Design Review Commission Report

Meeting Date: Thursday, October 1, 2015

Subject: **803 North Linden Drive (PL1522442)**
A request for an R-1 Design Review Permit to allow a new two-story single-family residence located in the Central Area of the City north of Santa Monica Boulevard. The Commission will also consider adoption of a Categorical Exemption, pursuant to the California Environmental Quality Act.

SHEET NO. A1.1

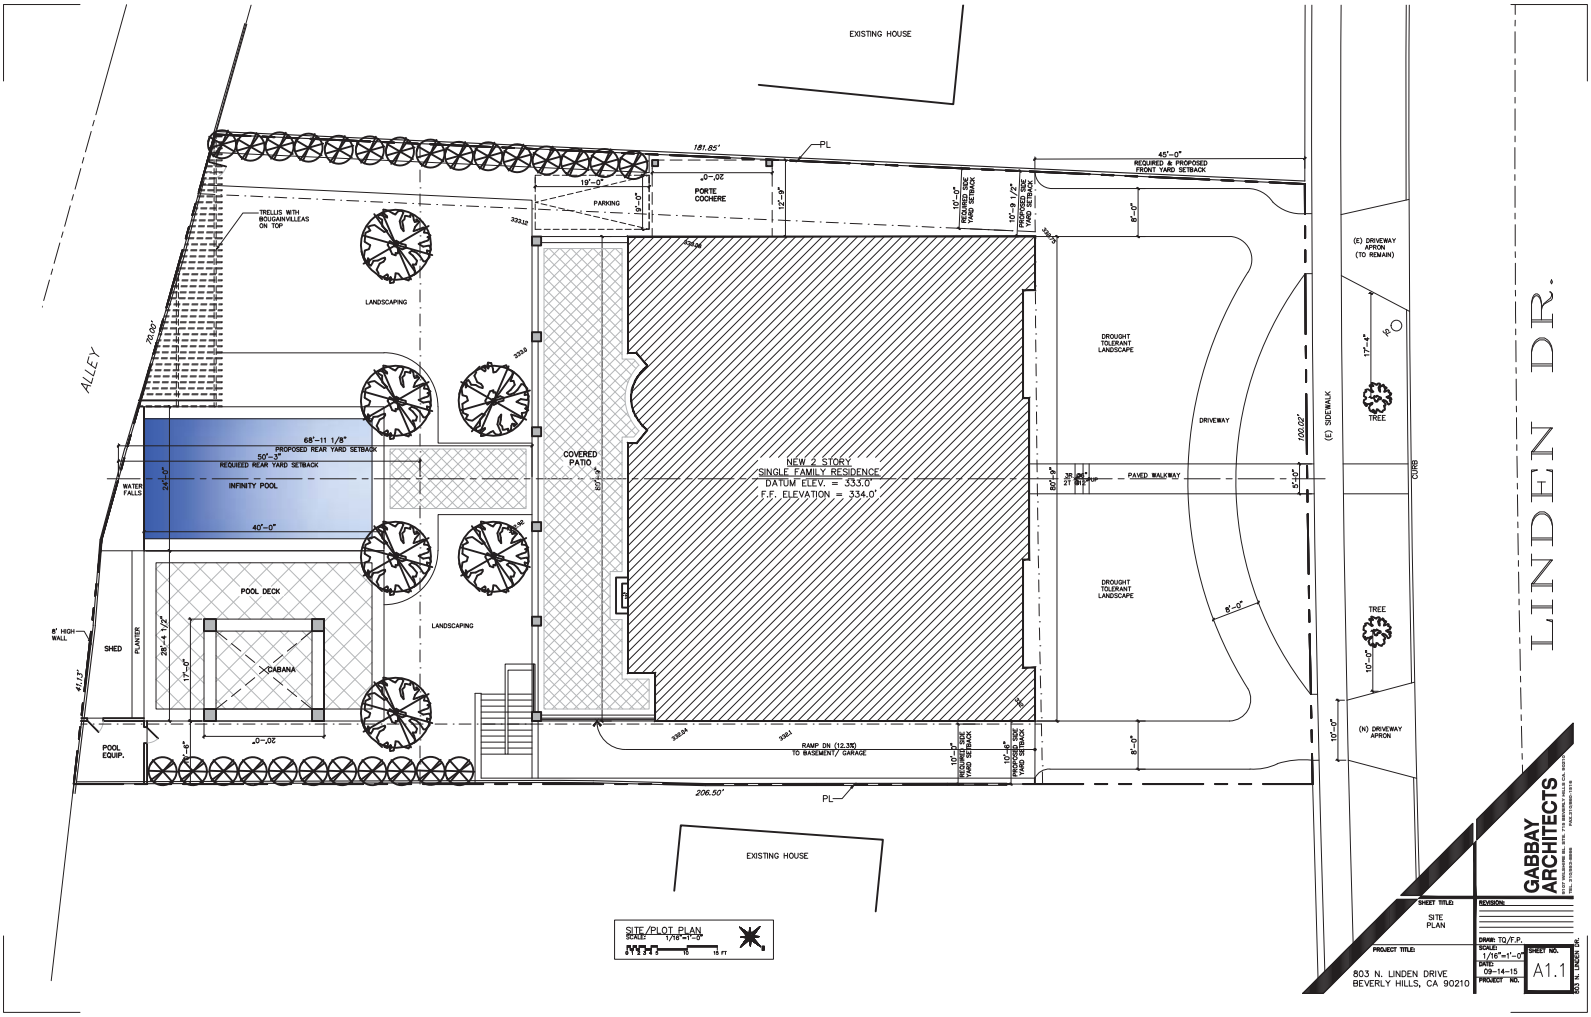
The front yard paving plan does not include the "Yosemite Cobble Stone Step Path" located alongside the driveway into the total paving calculation as required by Code nor does it include the required landscape paving buffer also required by the Code. A condition of approval has been included that requires a revised landscaping plan to be submitted for review and approval by staff prior to the plans being submitted to Building and Safety for plan check.

1. A revised front yard landscape plan that conforms to Code Section 10-3-2422 shall be submitted for review and approval by the Urban Design staff.

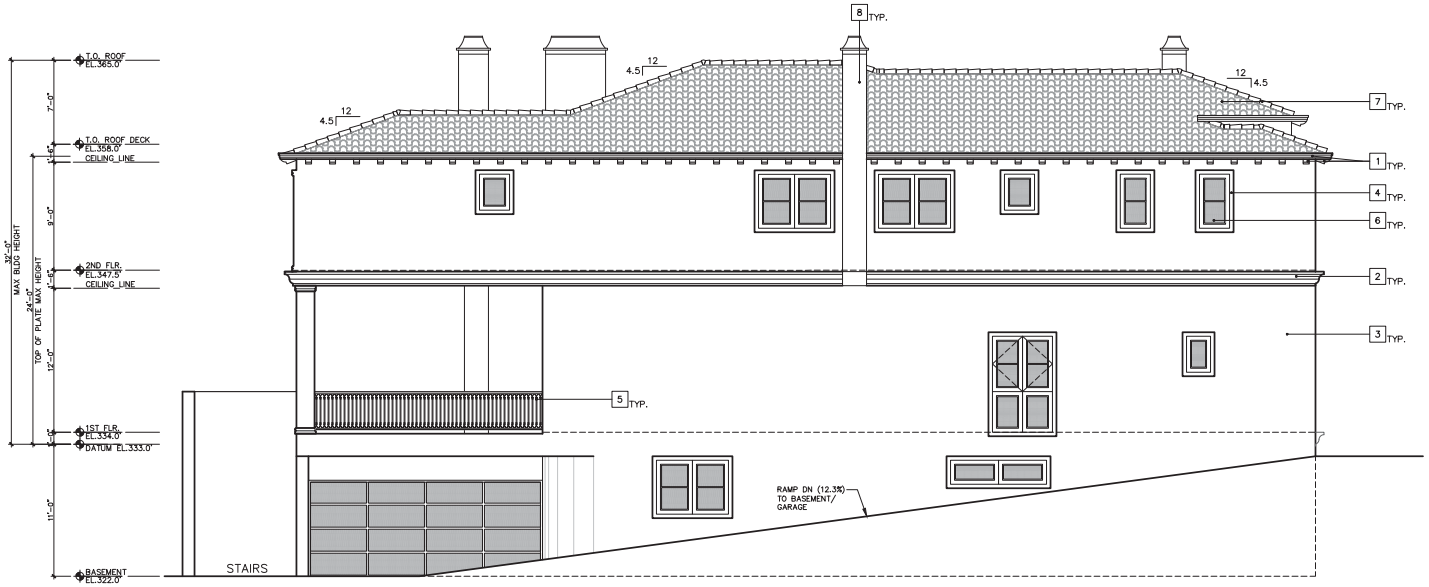
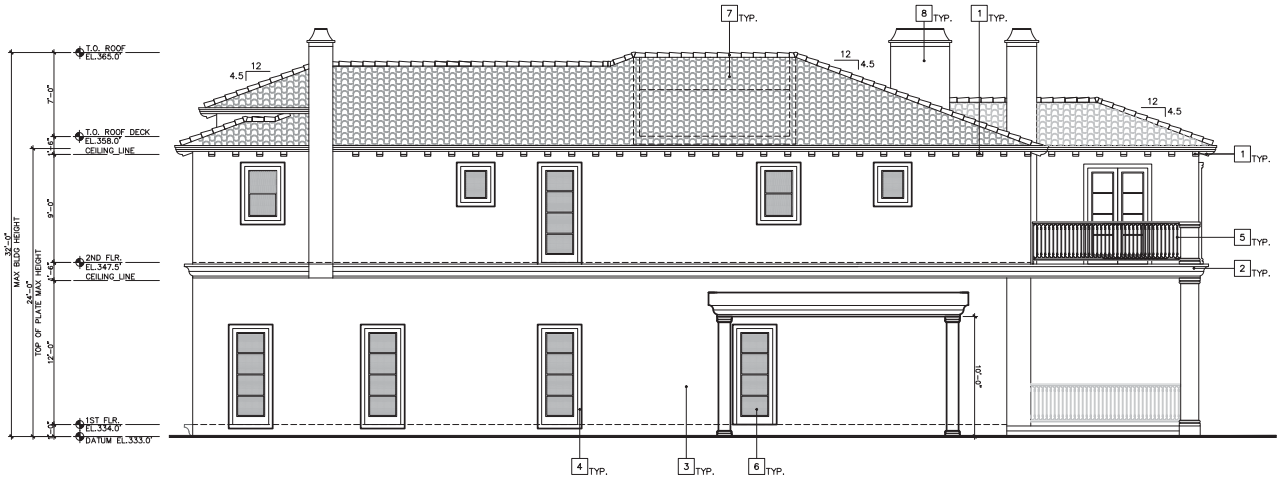
Based on a review conducted by the Urban Design Team, the proposed design could benefit from some secondary elements supporting the design. As shown the first and second floor could benefit from some design elements such as a precast trim around the base or a bead line on the upper floor to differentiate between the two floors. In addition, the design appears to have too many doors. Staff has not included project-specific conditions of approval related to these comments but the Commission may wish to consider these comments during their review and analysis of the project.
